Ella Mae Power Park Concession Building SP 08-44

Consideration of the request of City of Novi Parks, Recreation and Forestry Department for Preliminary Site Plan approval. The subject property is located in Section 27, south of Ten Mile Road between Taft and Novi Roads, in the R-4, One-Family Residential District. The subject site is approximately 1.3 acres of a 91 acre parcel and the applicant is proposing to construct a 1,309 square foot concession and restroom building to replace the existing concession and restroom building adjacent to the ballfields.

Planning Review

SP #08-44

Building Elevations

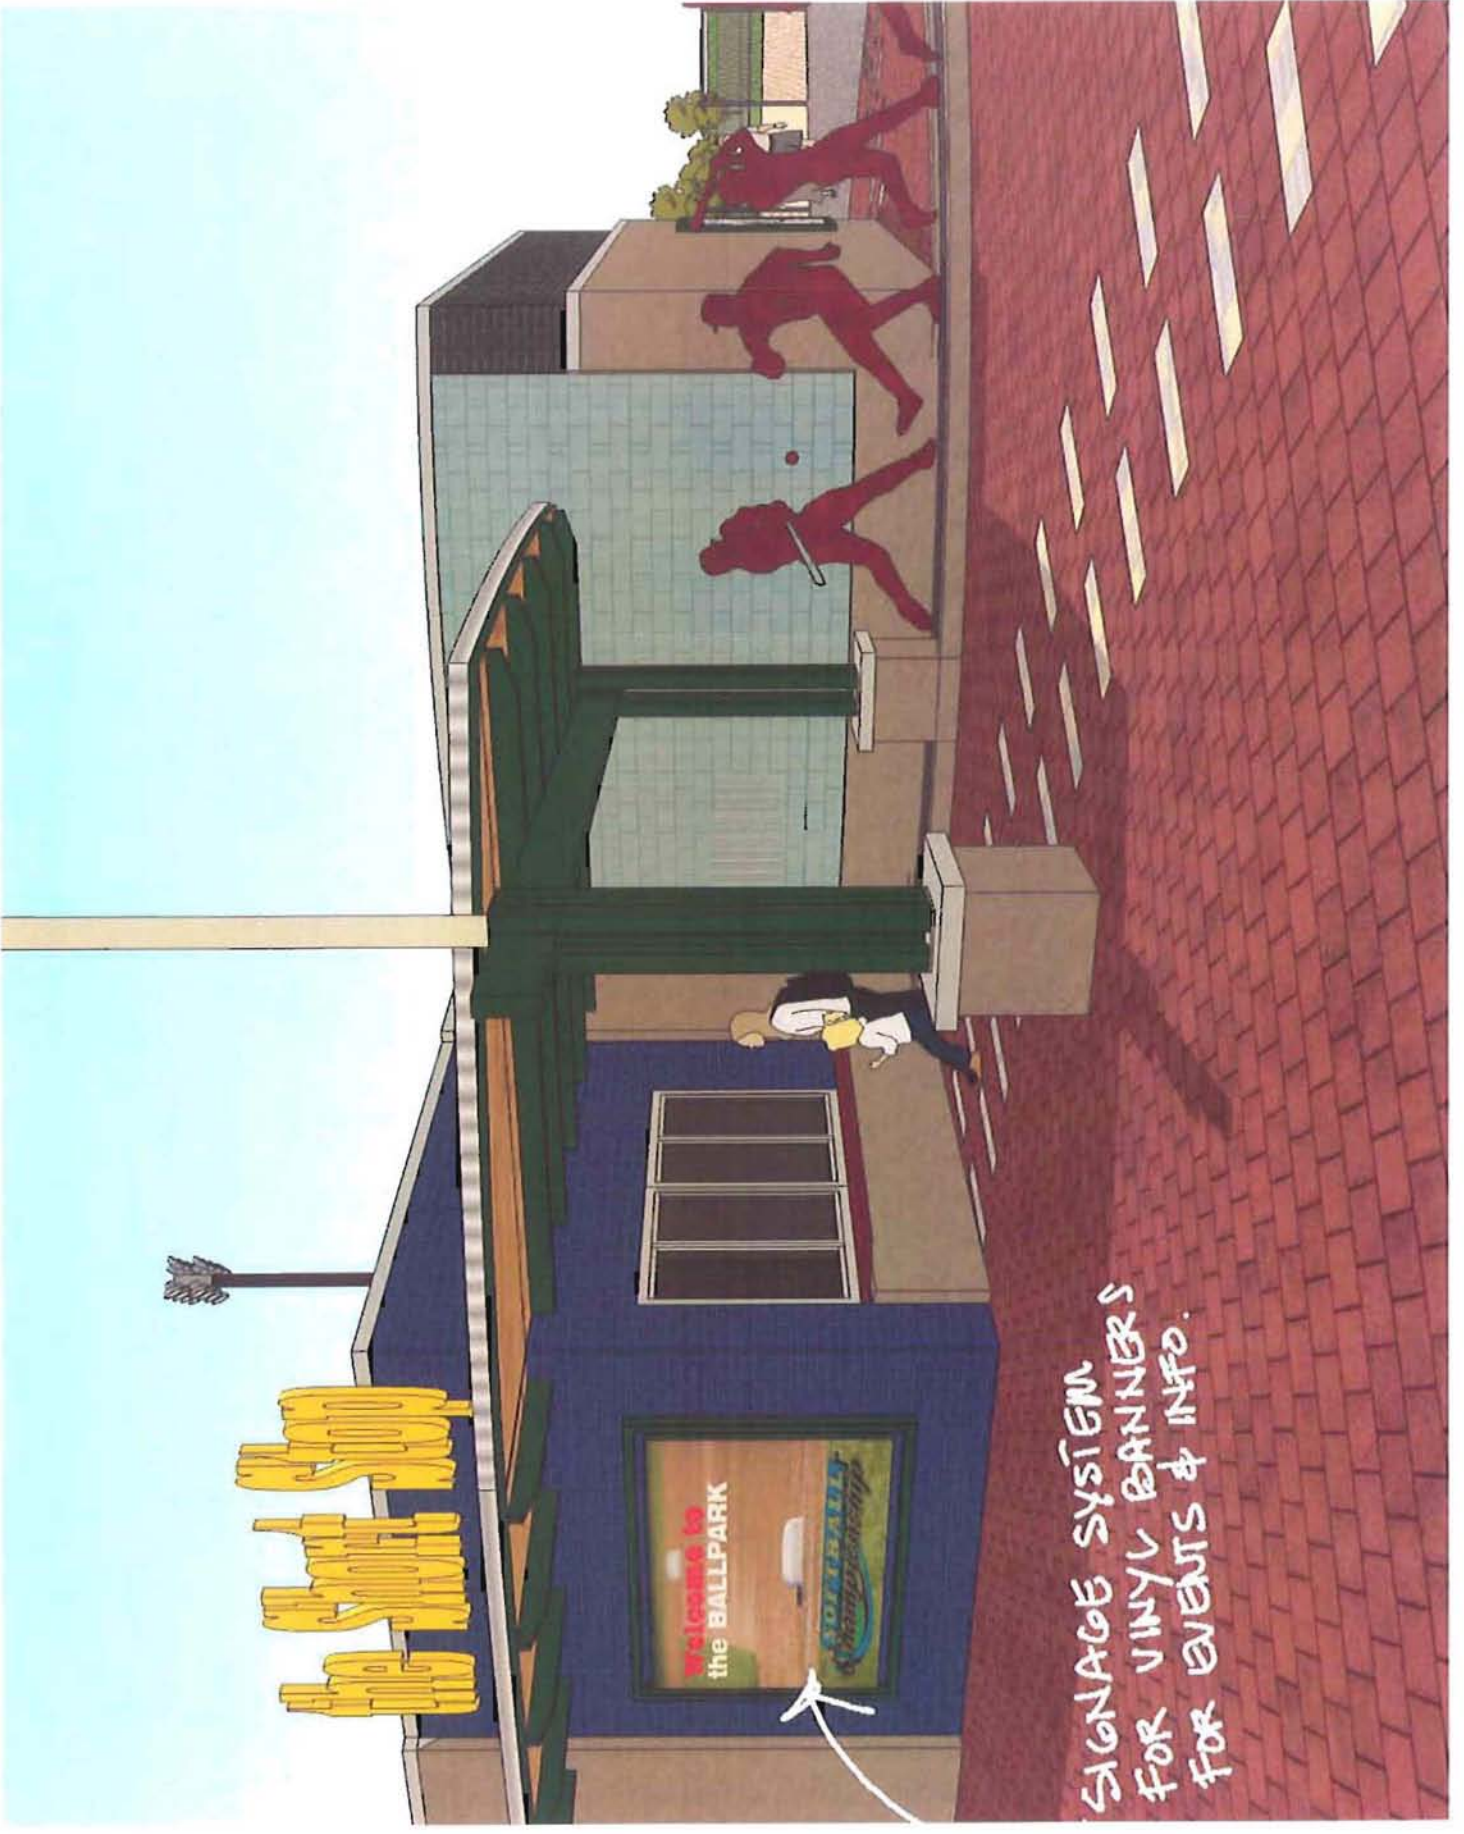
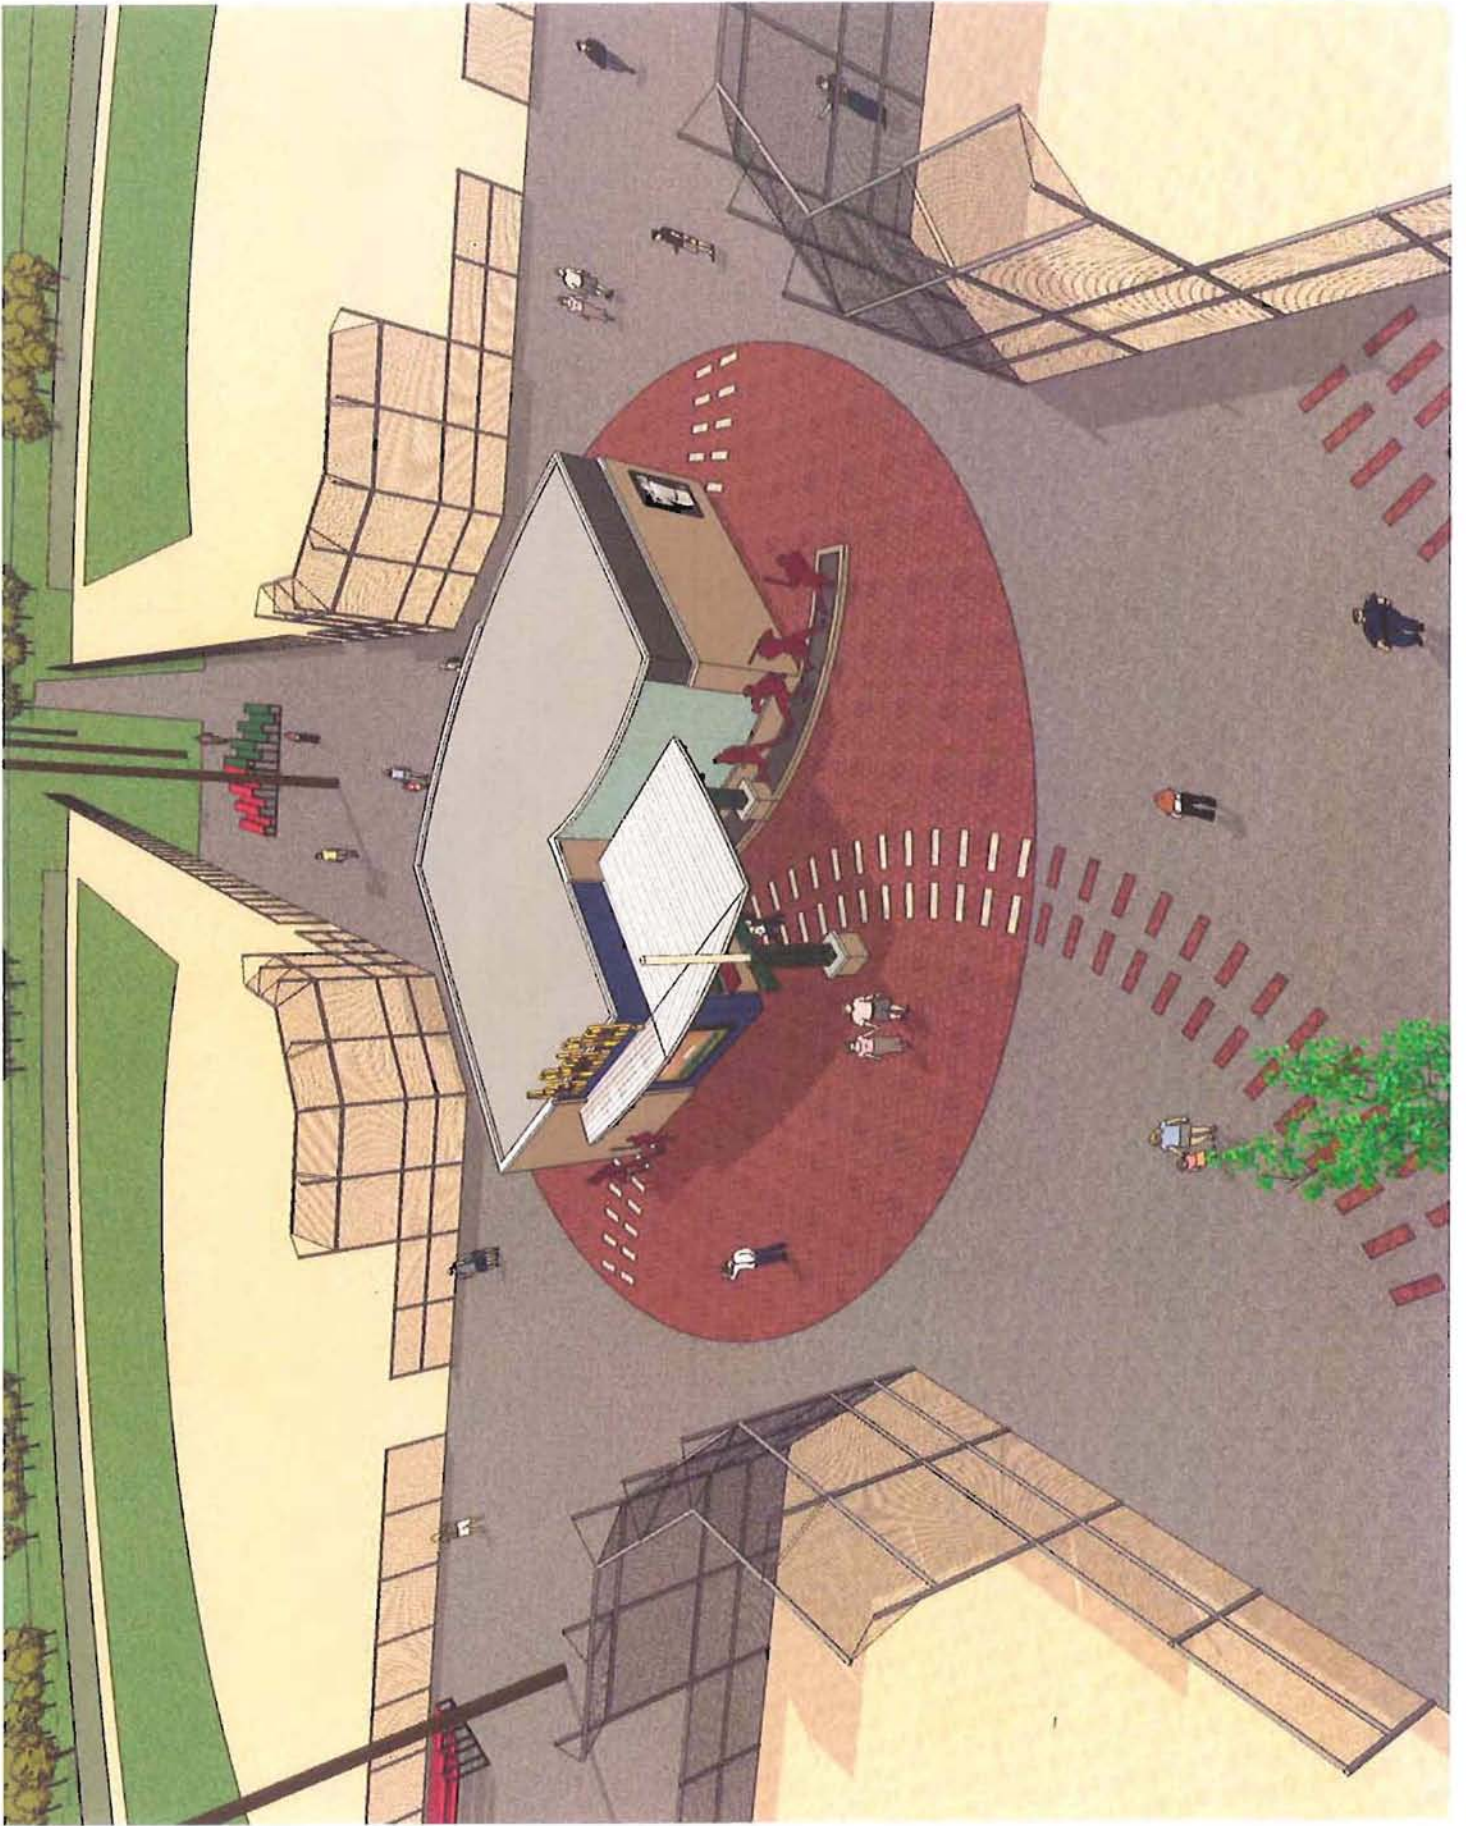
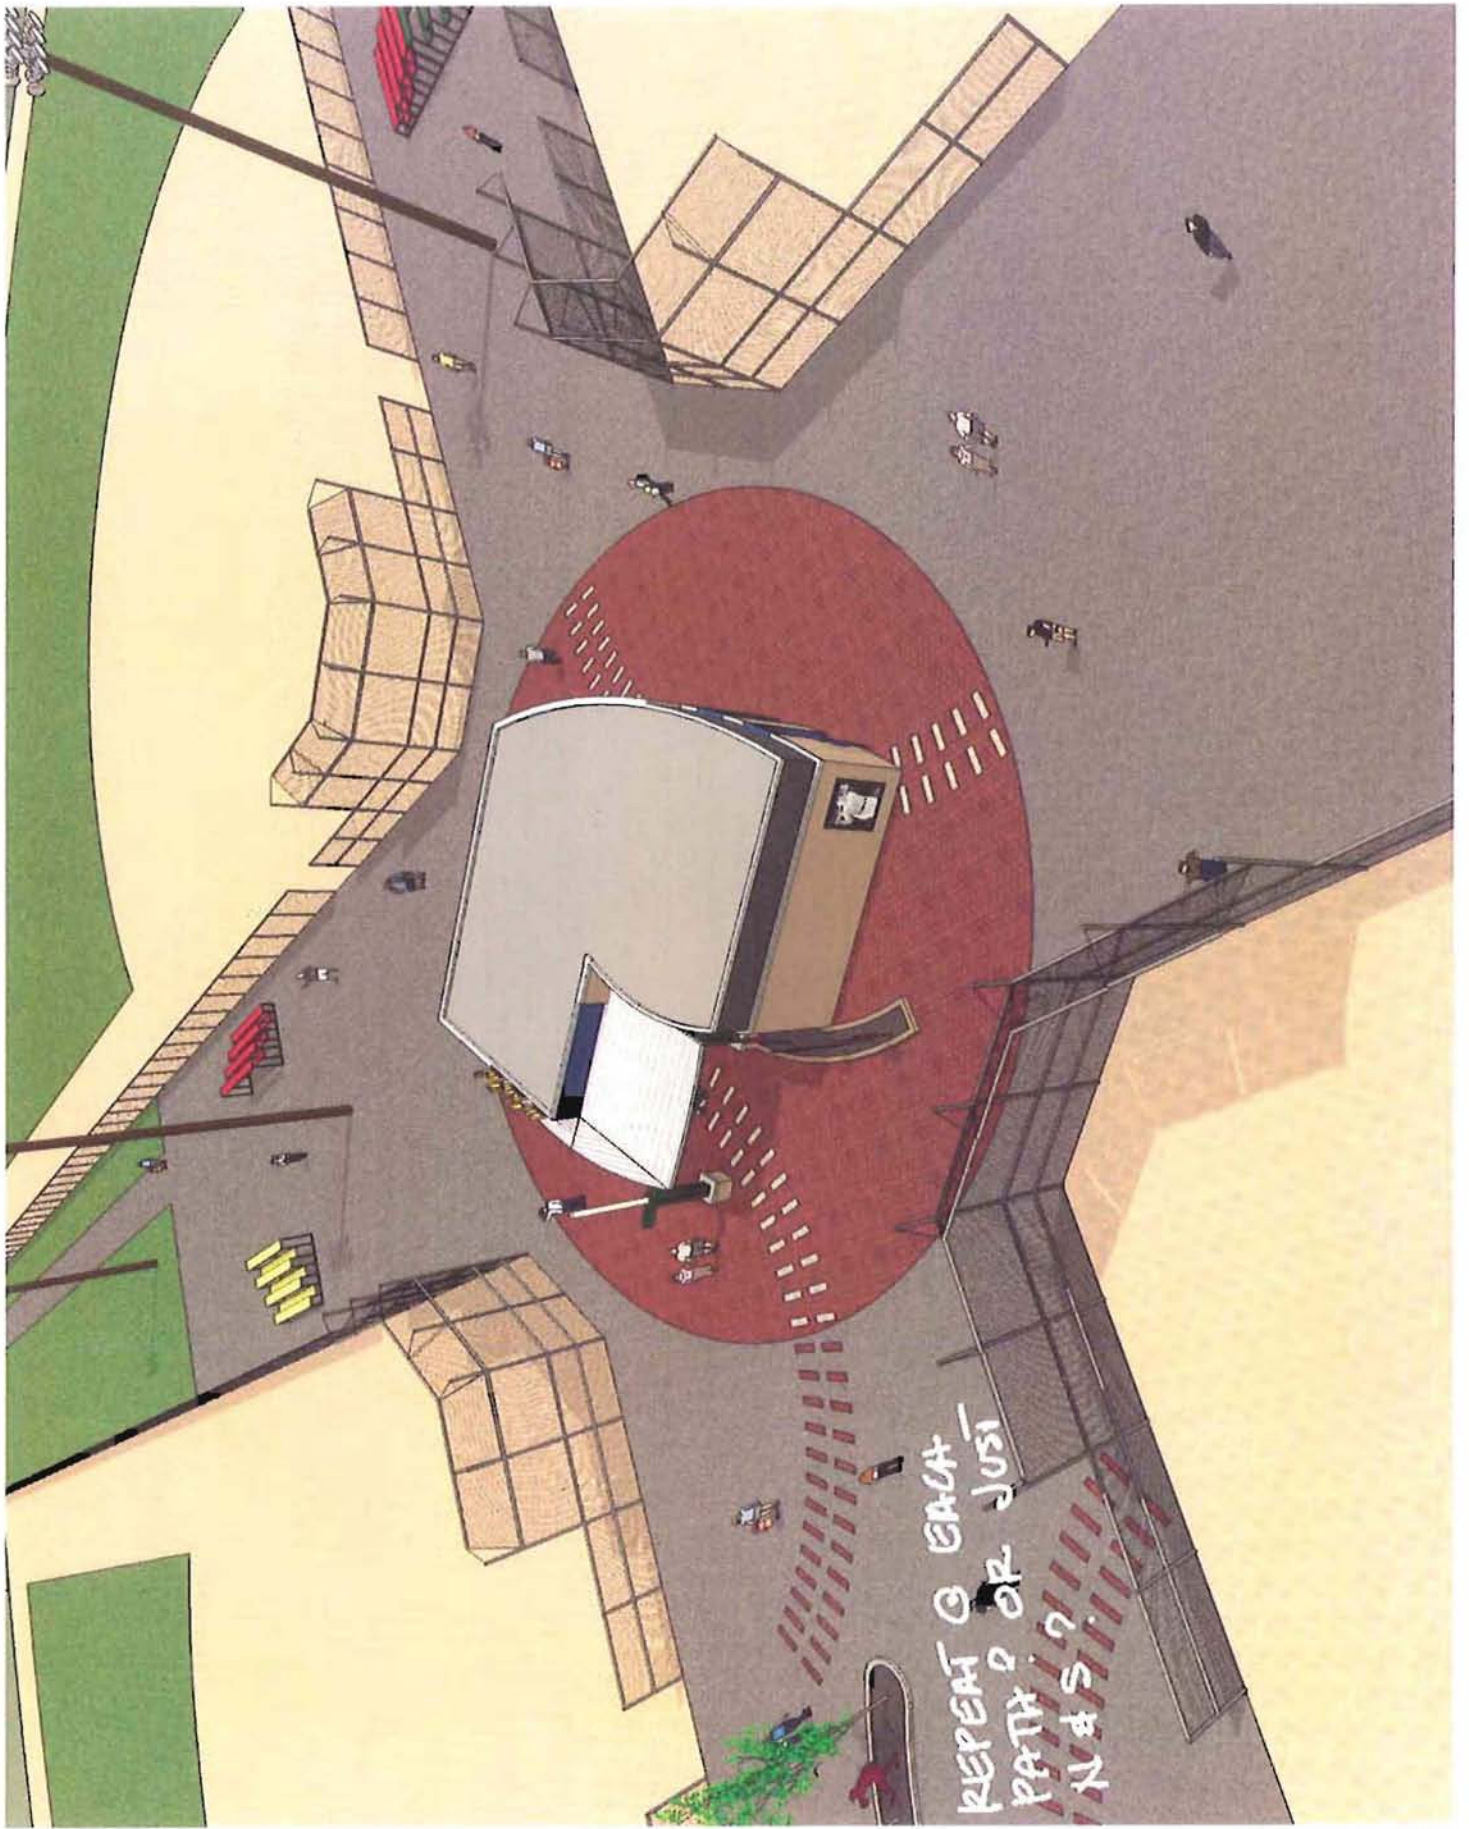
3. **Façade** (Sec. 2520) The proposed building **does not meet the façade material requirements of Region 1**. See the Façade Review for details and recommendations.

Comments: As shown above the Ground Faced CMU, Corrugated Fiberglass Panels and Glass Block are in non-compliance with the Façade Chart.

Recommendation: The overall design exhibits unique use of materials and interesting architectural elements that are consistent with the building’s use and location. The design therefore appears to be consistent with the intent and purpose of the Façade Ordinance. No sample board was provided at the time of this review therefore color selections could not be reviewed. This positive recommendation is contingent upon acceptable color selections consistent with other buildings on the City’s municipal campus (for example the dark brown masonry used on City Hall). Light colored units reminiscent of concrete block would not be permitted. We would also point out that the specifications indicate the Scored CMU is to have two (2) scores whereas the drawings depict a 3-score unit.
